Subject: Environmental Assessments - Prairie Creek Mine

- Phase II Mineral Exploration Drilling Program (MVEIRB File EA01-003)
- Metallurgical Pilot Plant Program and Underground Decline and Exploration Drilling (MVEIRB File EA01-002)

Environmental Assessment - Technical Review Information Request #1

**Canadian Zinc Corporation Prairie Creek Project
Decline Development, Exploration Drilling, and Metallurgical Pilot Plant Program**

Figure 1. Total groundwater volume is the integral of flow rate times the duration of flow.

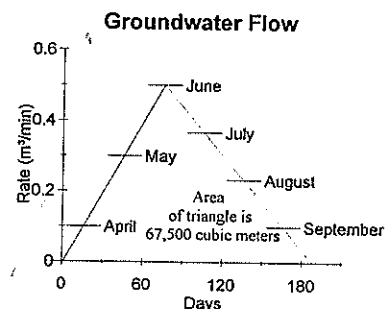
Preamble: The groundwater flows given for the 870m level adit suggest that throughout a summer about 67,500 m³ of groundwater can issue from this adit 20m above the 850m elevation of the mine site, which suggests that the adit intersected a seasonally perched aquifer. The proposed decline from the 905m level will descend to near the 825m level approximately 1460 m upstream of the mouth of Harrison Creek, where a greater hydraulic head may be encountered which is likely to produce greater flows than at the 870m level if the decline intersects a similar aquifer. The report also states that the probability of sump failure in the decline is "low" and the consequences of failure would be "small" volumes of "water and suspended solids", to "max. 50 gals.", which are "unlikely to migrate much beyond drill pad". A flow rate of 0.5 m³/min will yield 50 U.S. gals. in 2.5 minutes, and can potentially flood the end of a 15% decline (2.3m high by 3m wide) to the ceiling and 15m along its length in 1 hour.

Request: A statement is required of intent to monitor and report the rate of groundwater flow encountered in the decline, and to commission pumps capable of handling the flow, with sufficient backup pumps in the event of pump failure(s). Also requested is an analysis of the hydraulic conductivity of the flood plain sands and gravels using draw-down and pumping-volume data from well and pump hose No. 1, and information on what treatment of the tailings impoundment will be undertaken to counteract this hydraulic conductivity.
